HURRICANE PROTECTION

EMPIRE FLOODGATE

PERIODIC INSPECTION REPORT NO. 2

SUBJECT: New Orleans to Venice, Louisiana (Hurricane Protection);
Empire to the Gulf of Mexico Waterway; Empire Floodgate,
Periodic Inspection Report No. 2, October 1978

NEW ORLEANS TO VENICE, LA.
HURRICANE PROTECTION REACH B-1
PERIODIC INSPECTION
EMPIRE FLOODGATE
ALINEMENT AND SETTLEMENT
REFERENCE MARKS - TABULATIONS
U.S. ARMY ENGINEER DISTRICT, NEW ORLEANS
CORPS OF ENGINEERS
SHEET OF SHEET FILE NO. H-4-27323/

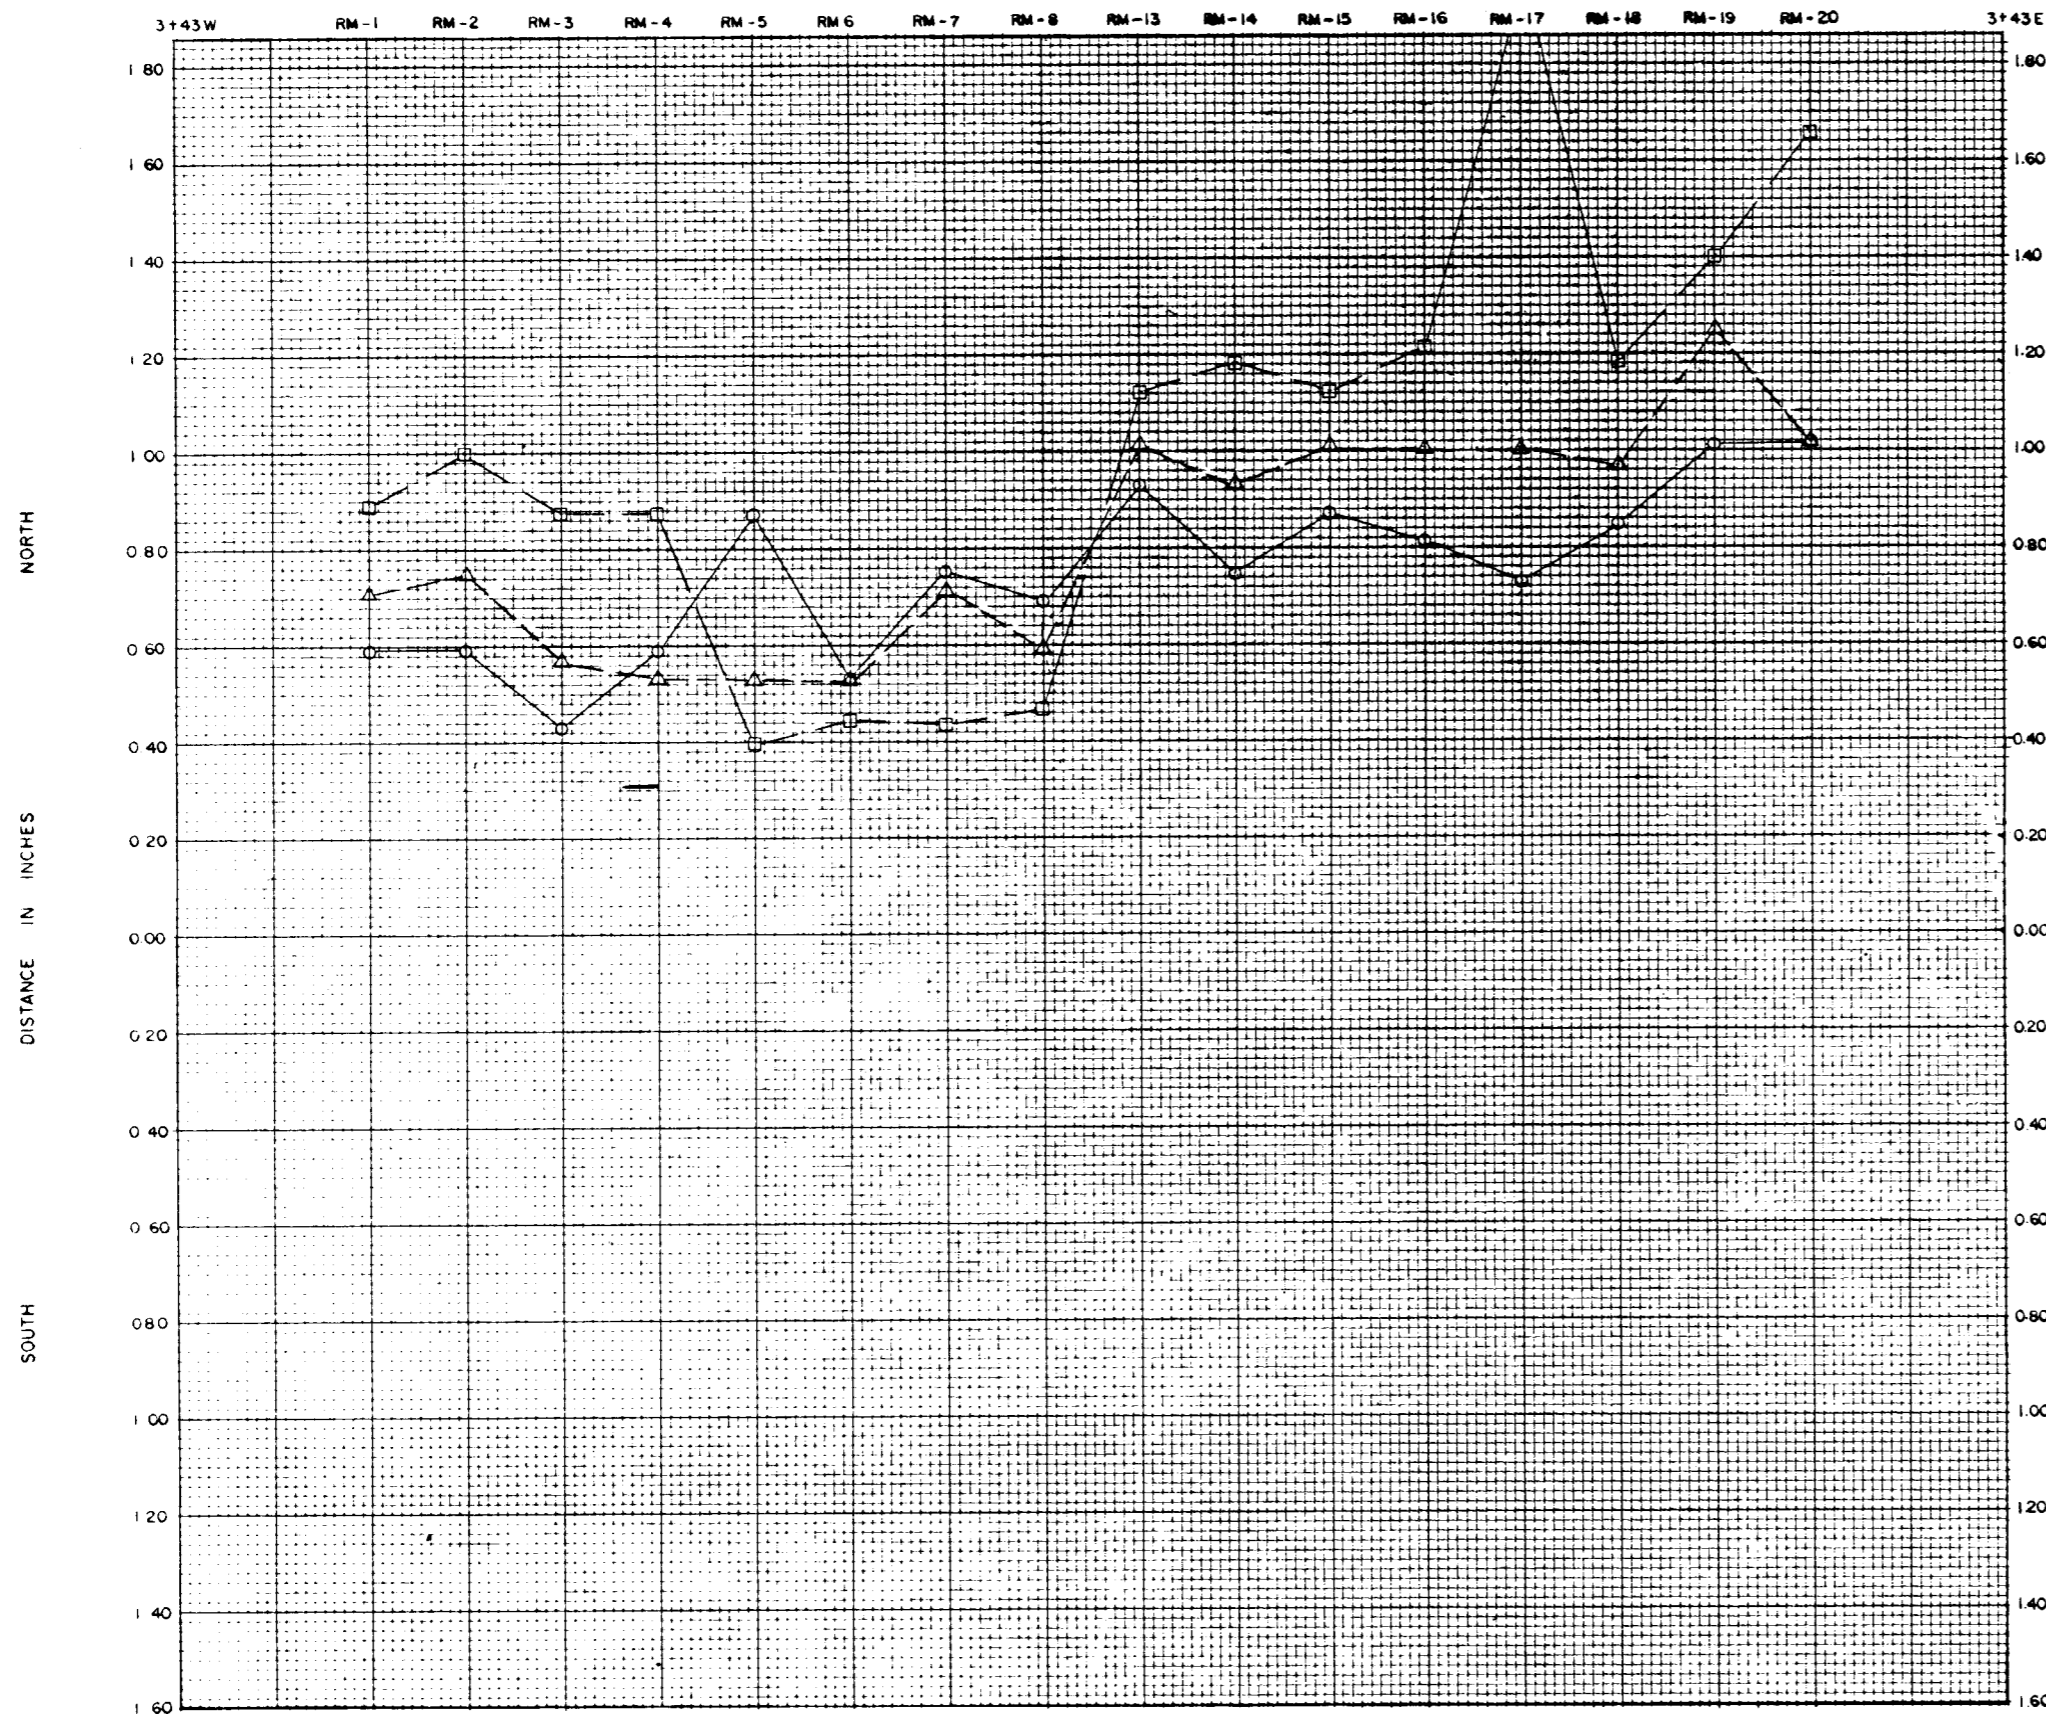
c. Para 4-02b and Plate I-2.

(1) The third sentence states that the survey of September 1978
shows some settlements and some rebounds. The data presented on Plate I-2
show no rebound of the structure and T-wall. Rebound is shown for some
points on the sheet piling and levee. This paragraph should be revised
for clarity.

(2) In future similar inspection reports for this project, the
settlement reference mark data for the sheet piling and levee shown on
Plate I-2 should be plotted on a plate similar to Plates I-3 and I-4.

b. In future similar inspection reports, the location map will be
included, and the settlement data for the sheet piling and levee will be
plotted similar to Plates I-3 and I-4.
